SUBJECT: ISSUANCE OF AMENDMENTS - JOSEPH M. FARLEY NUCLEAR PLANT,
 UNITS 1 AND 2 (TAC NOS. M99136 AND M99137)

The Nuclear Regulatory Commission has issued the enclosed Amendment No. 133 to Facility Operating License No. NPF-2 and Amendment No. 125 to Facility Operating License No. NPF-8 for the Joseph M. Farley Nuclear Plant, Units 1 and 2. The amendments change the Technical Specifications (TS) in response to your submittal dated June 30, 1997, as supplemented September 25, 1997. The revision supplemented the TS Bases to discuss credit for boraflex panels in the revised criticality analysis. The staff found that the supplement did not change the conclusions of the proposed no significant hazards consideration; therefore, renotification of the Commission's proposed determination of no significant hazards consideration was not necessary.

The amendments change the Farley TS to incorporate requirements necessary to change the basis for prevention of criticality in the fuel storage pool. The change eliminates the credit for Boraflex as a neutron absorbing material in the fuel storage pool criticality analysis. The change also establishes an alternate method for maintaining the recomm

Figure 3.7-1 Fuel Assembly Burnup Limit Requirements For All Cell Storage

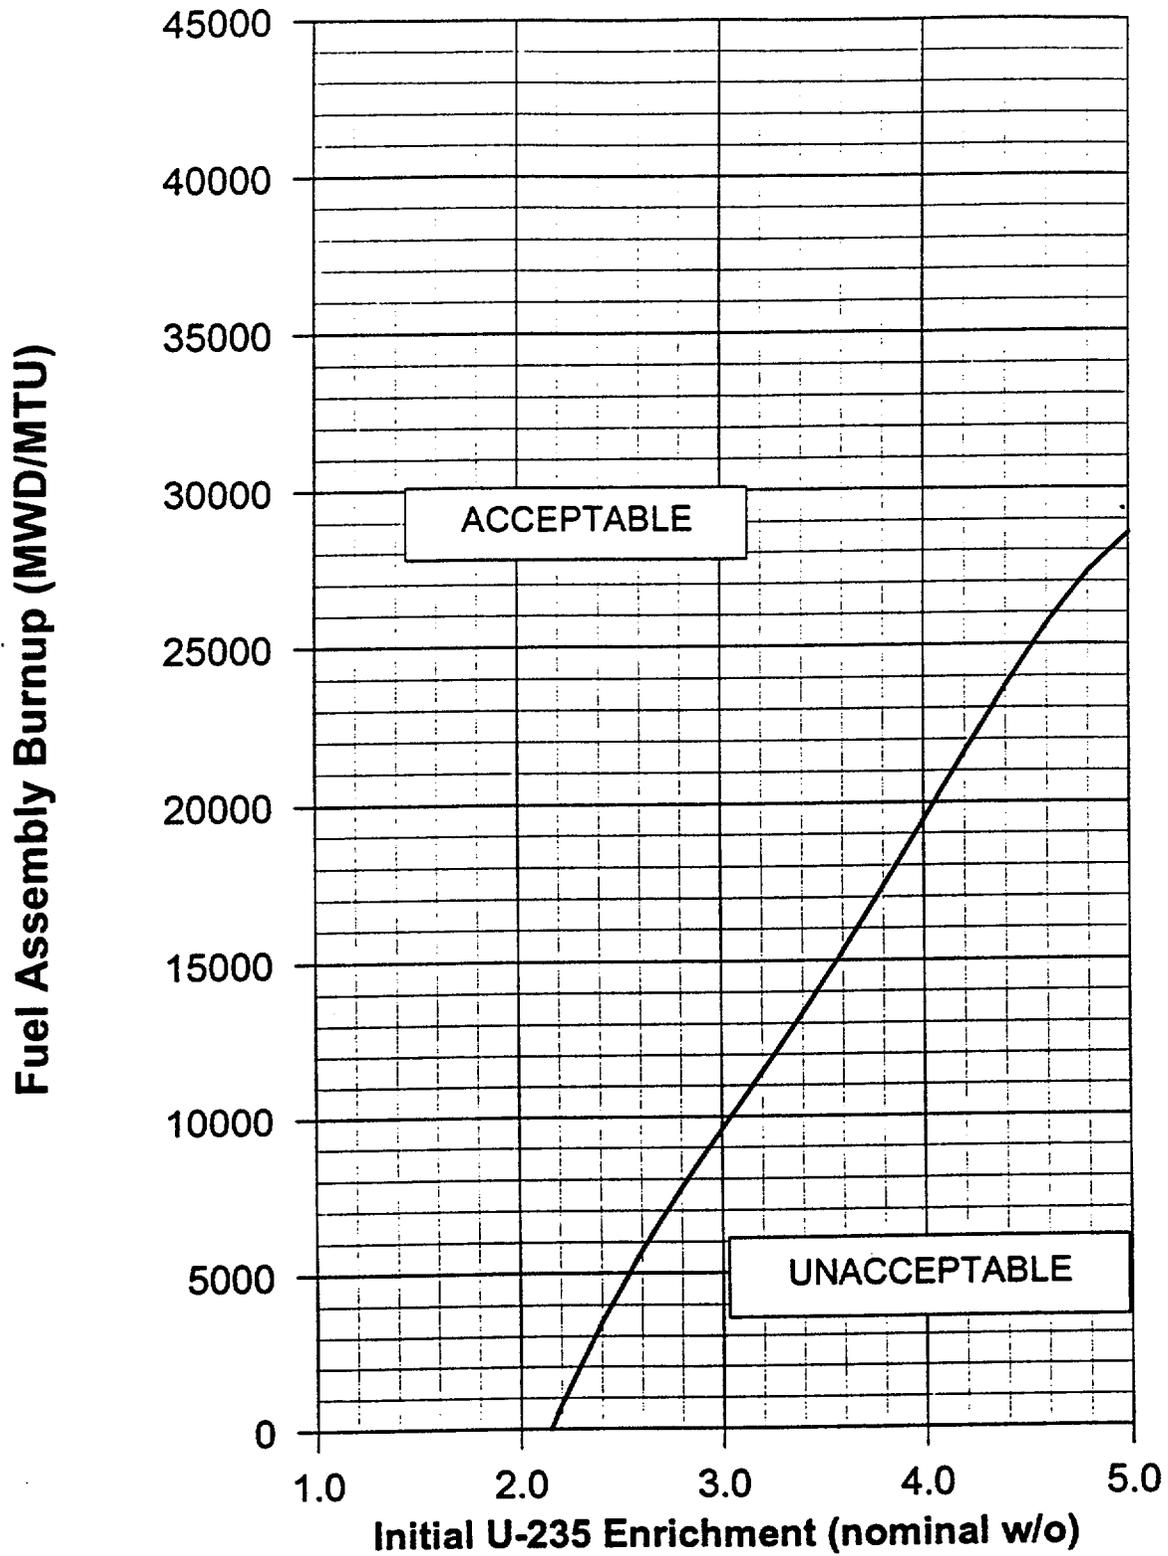
3.7.14 The combination of initial enrichment and burnup of each fuel assembly stored in the spent fuel storage pool shall be within the Acceptable Burnup Domain of Figure 3.7-1, or shall be stored in accordance with Specification 5.6.1.1.

- e. New or partially spent fuel assemblies with a combination of discharge burnup and initial enrichment in the "acceptable range" of Figure 3.7-1 may be allowed unrestricted storage in the spent fuel racks (also shown as the All Cell Storage configuration in Figure 5.6-2).

Westinghouse 17X17 fuel assemblies with nominal enrichments less than or equal to 2.15 w/o U-235 can be stored in any cell location as shown in Figure 5.6-2. Fuel assemblies with initial nominal enrichments greater than these limits must satisfy a minimum burnup requirement as shown in Figure 3.7-1.

Figure 5.6-1 Fuel Assembly Burnup Limit Requirements for Low Enrichment (L)
 Assembly of the Burned/Fresh Checkerboard Storage (see Figure 5.6-2)

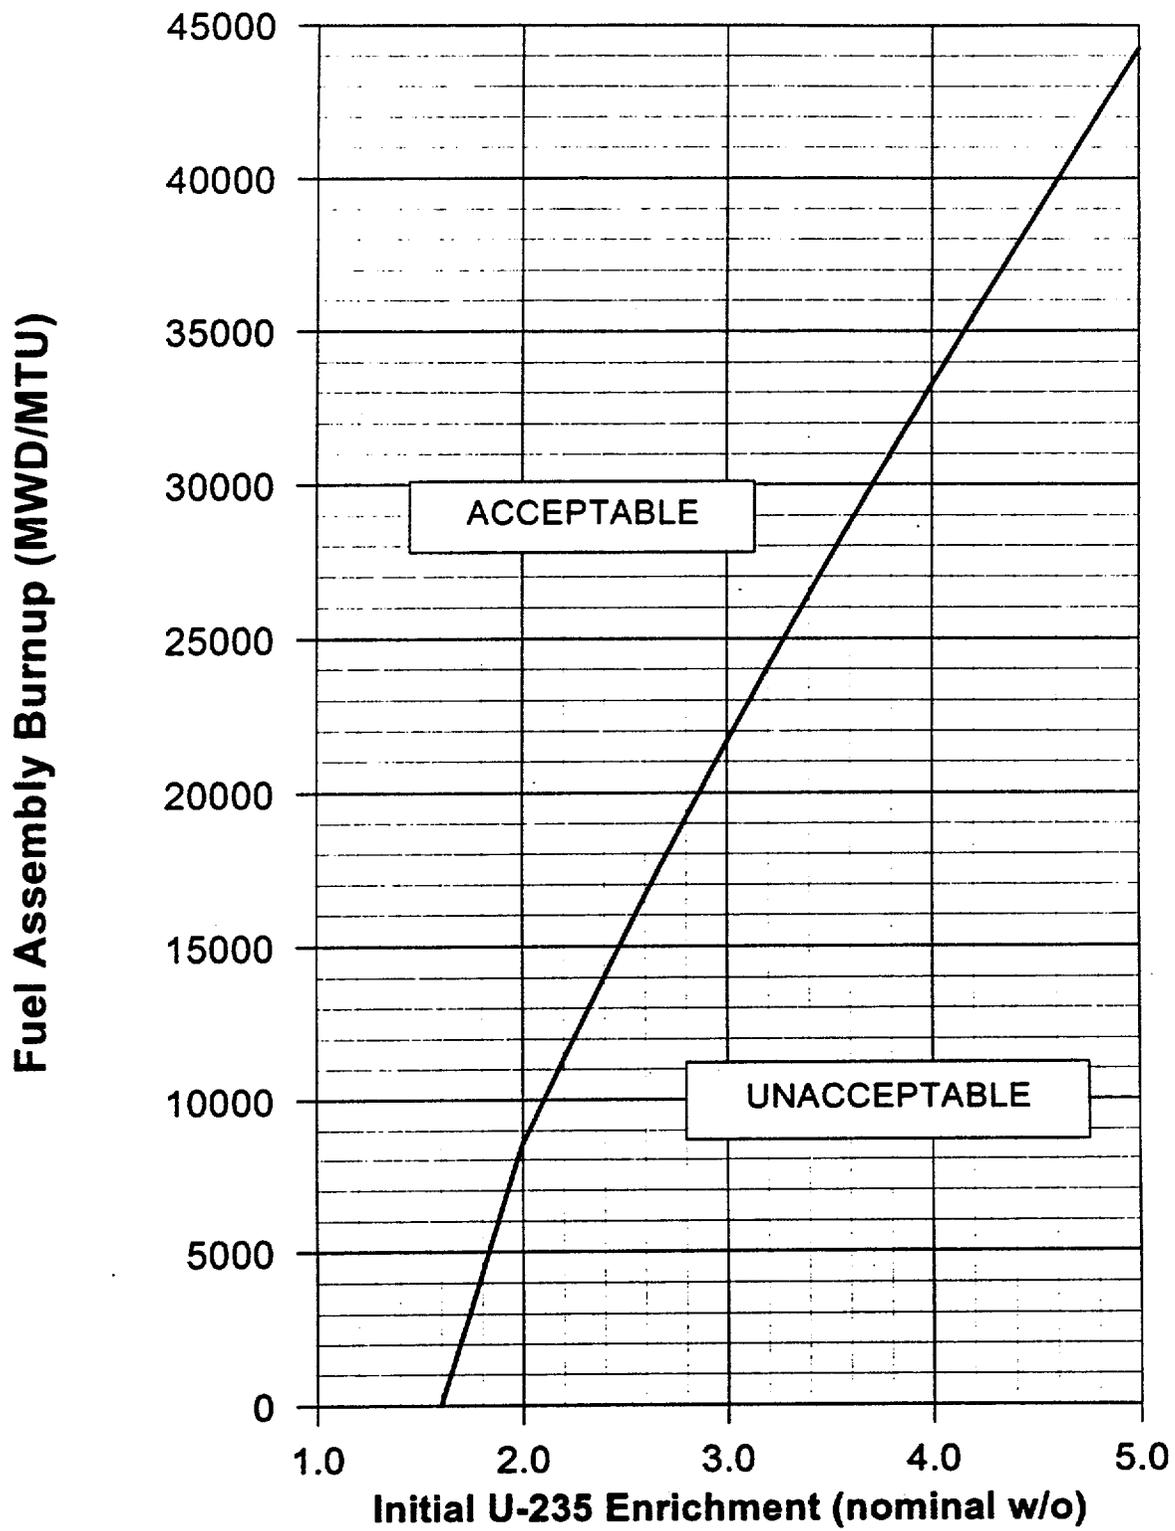
- f. New or partially spent fuel assemblies with a combination of discharge burnup and initial enrichment in the "unacceptable range" of Figure 3.7-1 will be stored in compliance with Figures 5.6-1 through 5.6-5. The high enrichment fuel assemblies shown in the Burned/Fresh Storage configuration in Figure 5.6-2, with maximum nominal enrichments greater than 3.9 w/o U-235, shall contain sufficient integral burnable absorbers such that a maximum reference fuel assembly k_{∞} less than or equal to 1.455 at 68°F is maintained.

Figure 5.6-2 Spent Fuel Storage Configurations

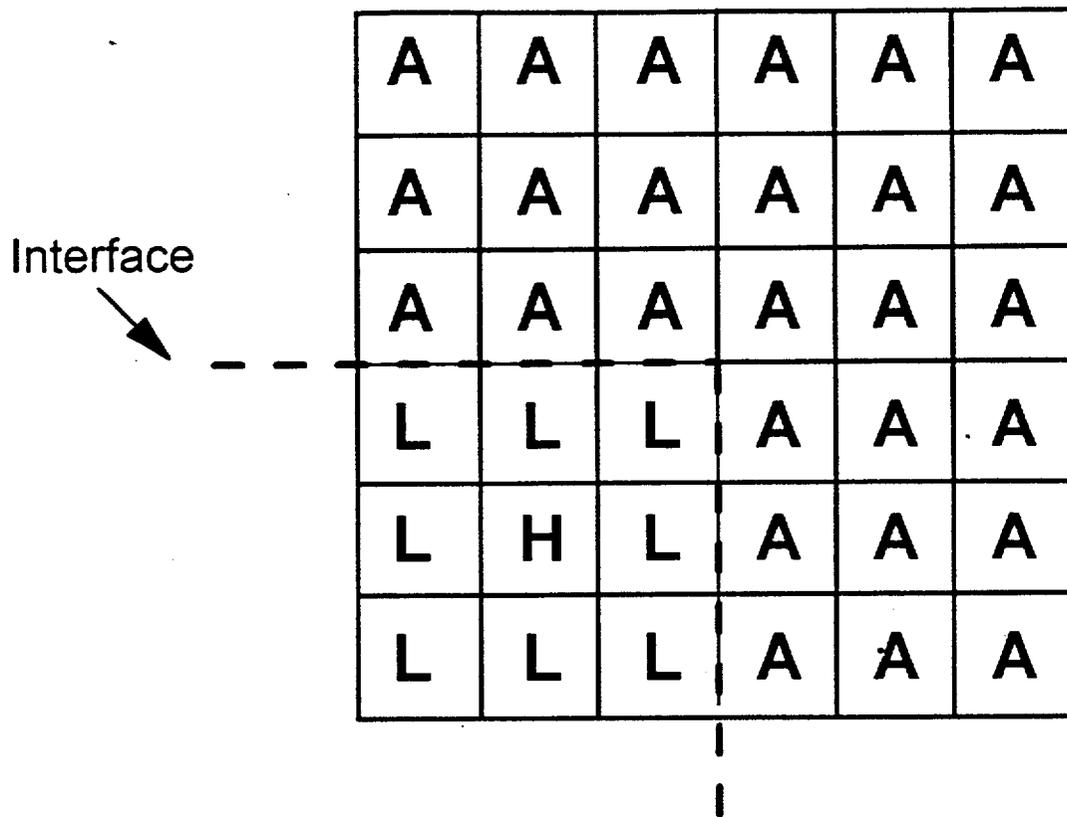
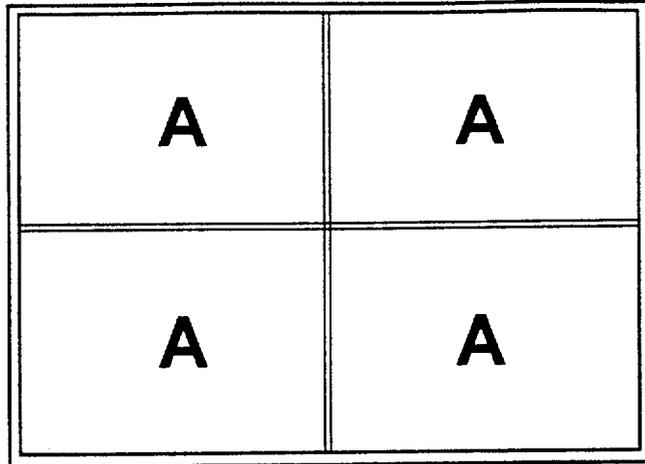
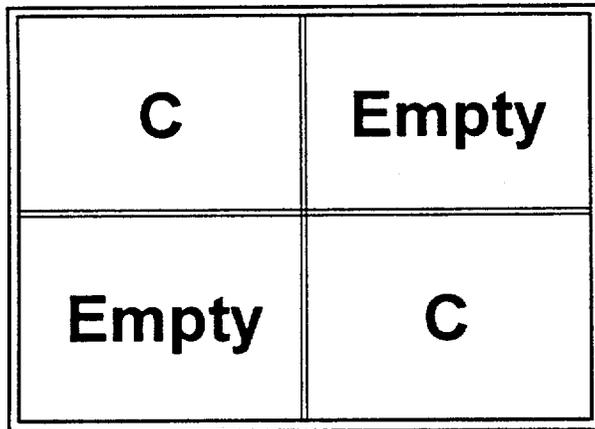
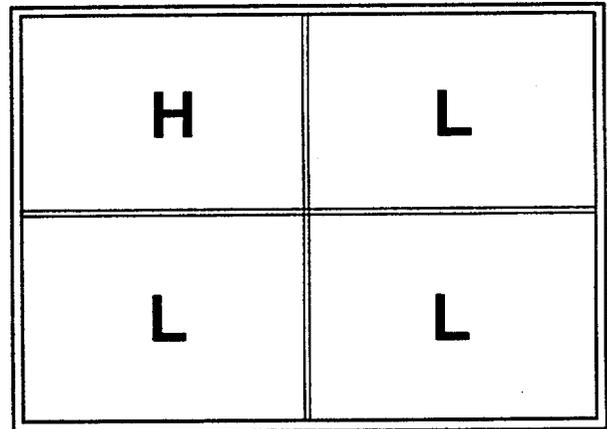
Westinghouse 17X17 fuel assemblies with nominal enrichments less than or equal to 5.0 w/o U-235 can be stored in a 2 out of 4 checkerboard arrangement as shown in Figure 5.6-2. In the 2 out of 4 checkerboard storage arrangement, 2 fuel assemblies can be stored corner adjacent with 2 empty storage cells.

Westinghouse 17X17 fuel assemblies can be stored in a burned/fresh checkerboard arrangement of a 2X2 matrix of storage cells as shown in Figure 5.6-2. In the burned/fresh 2X2 checkerboard arrangement, three of the fuel assemblies must have an initial nominal enrichment less than or equal to 1.6 w/o U-235, or satisfy a minimum burnup requirement for higher initial enrichments as shown in Figure 5.6-1. The fourth fuel assembly must have an initial nominal enrichment less than or equal to 3.9 w/o U-235, or satisfy a minimum Integral Fuel Burnable Absorber requirement for higher initial enrichments to maintain the reference fuel assembly k_{eff} less than or equal to 1.455 at 68° F.

Figure 3.7-1 Fuel Assembly Burnup Limit Requirements For All Cell Storage

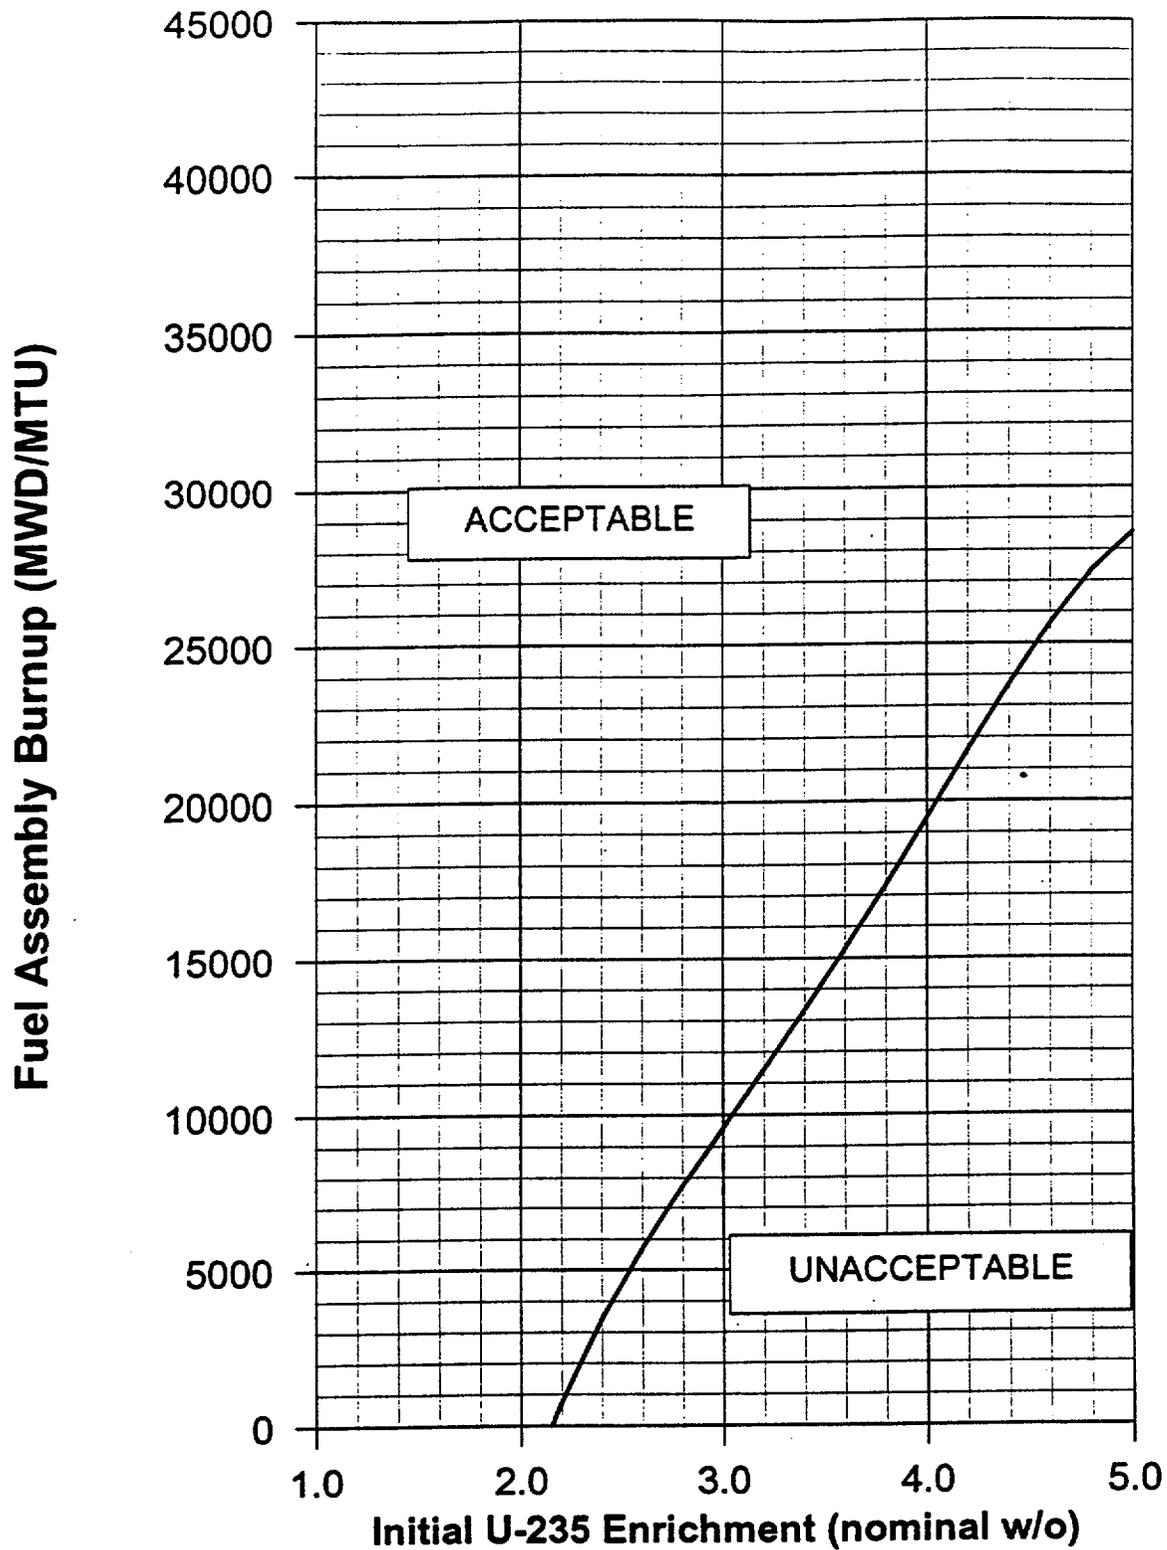
3.7.15 The combination of initial enrichment and burnup of each fuel assembly stored in the spent fuel storage pool shall be within the Acceptable Burnup Domain of Figure 3.7-1, or shall be stored in accordance with Specification 5.6.1.1.

- e. New or partially spent fuel assemblies with a combination of discharge burnup and initial enrichment in the "acceptable range" of Figure 3.7-1 may be allowed unrestricted storage in the spent fuel racks (also shown as the All Cell Storage configuration in Figure 5.6-2).

Westinghouse 17X17 fuel assemblies with nominal enrichments less than or equal 2.15 w/o U-235 can be stored in any cell location as shown in Figure 5.6-2. Fuel assemblies with initial nominal enrichments greater than these limits must satisfy a minimum burnup requirement as shown in Figure 3.7-1.

Figure 5.6-1 Fuel Assembly Burnup Limit Requirements for Low Enrichment (L) Assembly of the Burned/Fresh Checkerboard Storage (see Figure 5.6-2)

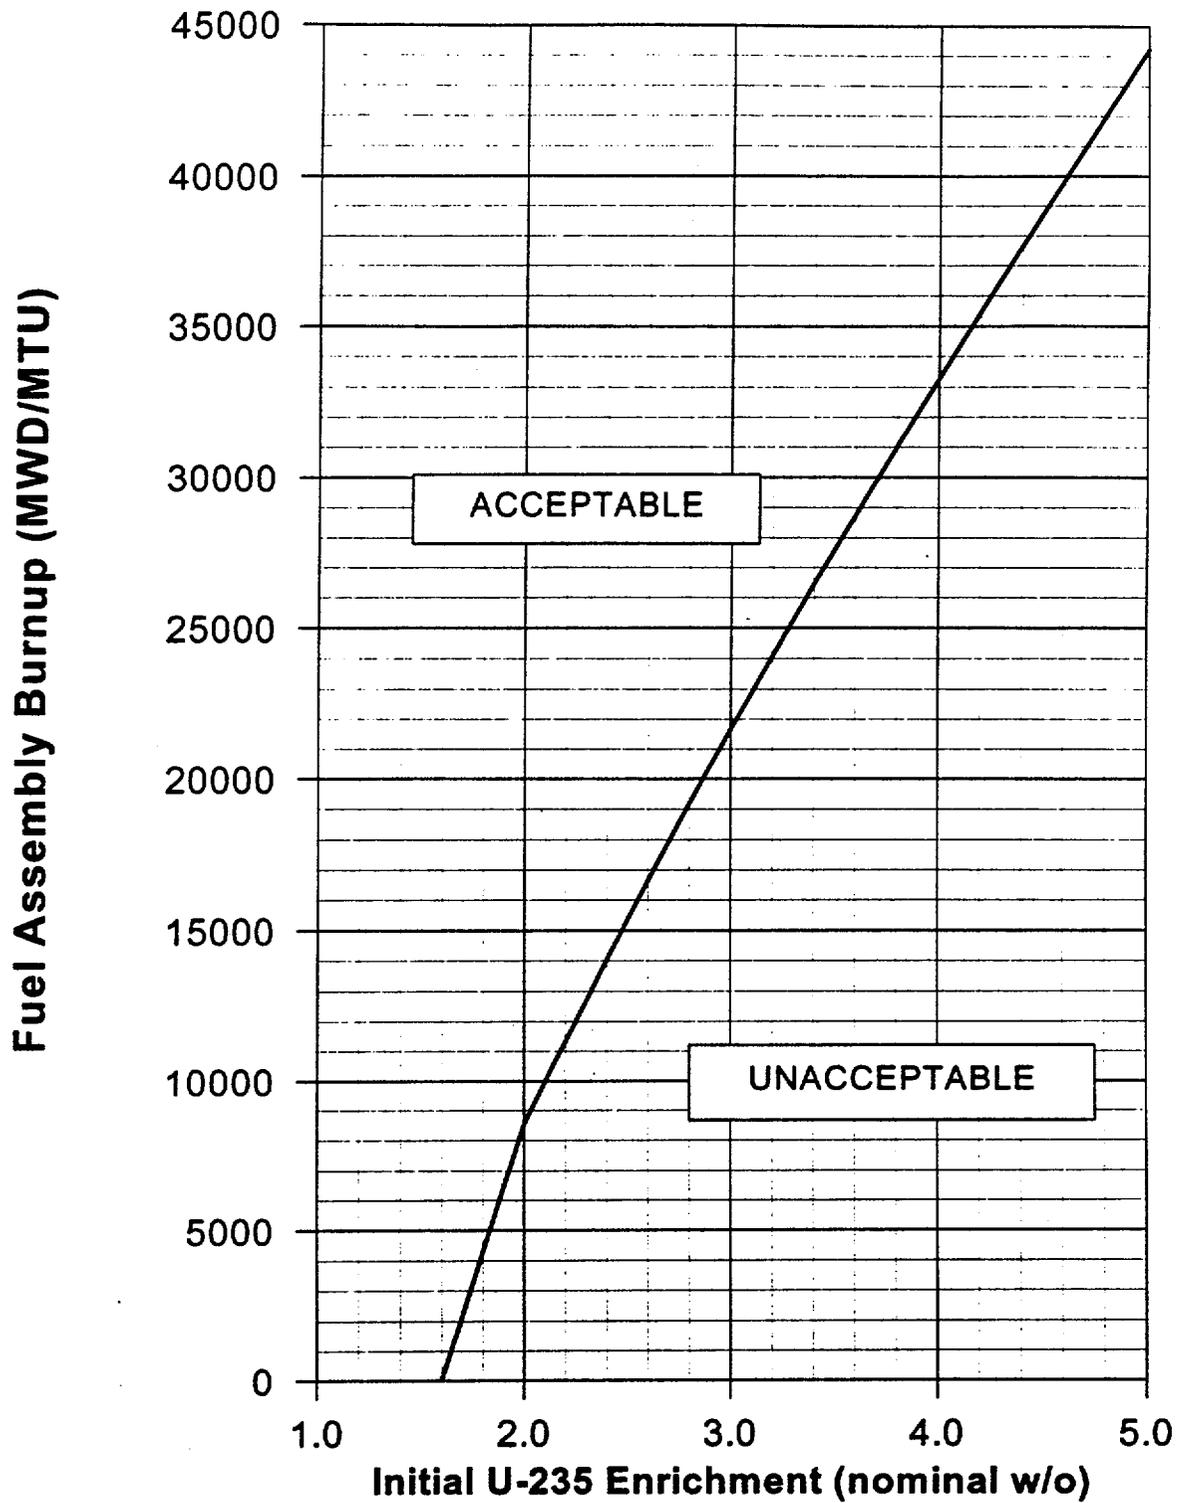
- f. New or partially spent fuel assemblies with a combination of discharge burnup and initial enrichment in the "unacceptable range" of Figure 3.7-1 will be stored in compliance with Figures 5.6-1 through 5.6-5. The high enrichment fuel assemblies shown in the Burned/Fresh Storage configuration in Figure 5.6-2, with maximum nominal enrichments greater than 3.9 w/o U-235, shall contain sufficient integral burnable absorbers such that a maximum reference fuel assembly k_{∞} less than or equal to 1.455 at 68°F is maintained.
